SUNDRY NOTICES AND REPORTS ON WELLS
Do not use this form for proposals to drill or to re-enter an abandoned well. Use Form 3160-3 (APD) for such proposals.

8. Well Name and No.
RUSSELL 8 FEDERAL #1

9. API Well No.
30-015-31392

PROPOSED PLUG & ABANDONMENT

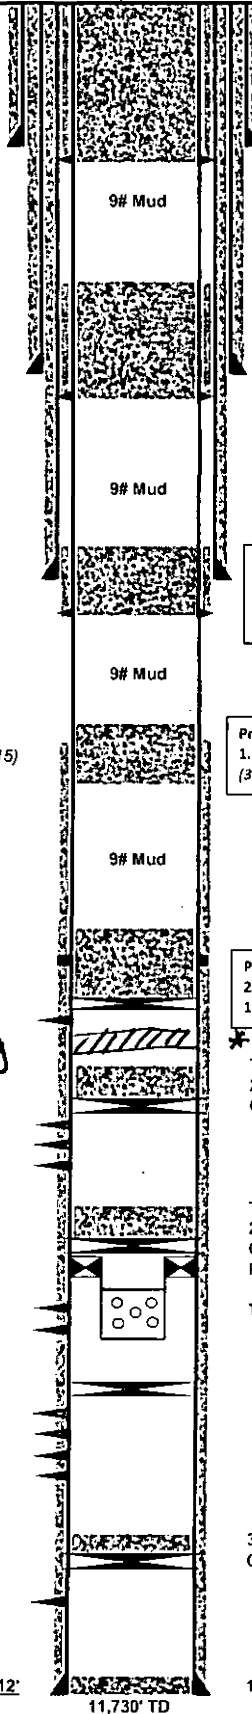
* Add plug - spot 25sx @ 9,122' - 9,222'

Proposed:
2. Spot 30 sx (230') CI H @ 9,400' - 8,870'.
1. Set CIBP @ 9,400'. Tag plug. 9080
* 1. Spot 25 sx @ 9422-9222
Tagged TOC @ 10,542'. (8/7/15)
25 sx CI H on top. (8/6/15)
CIBP @ 10,750' (8/4/15)
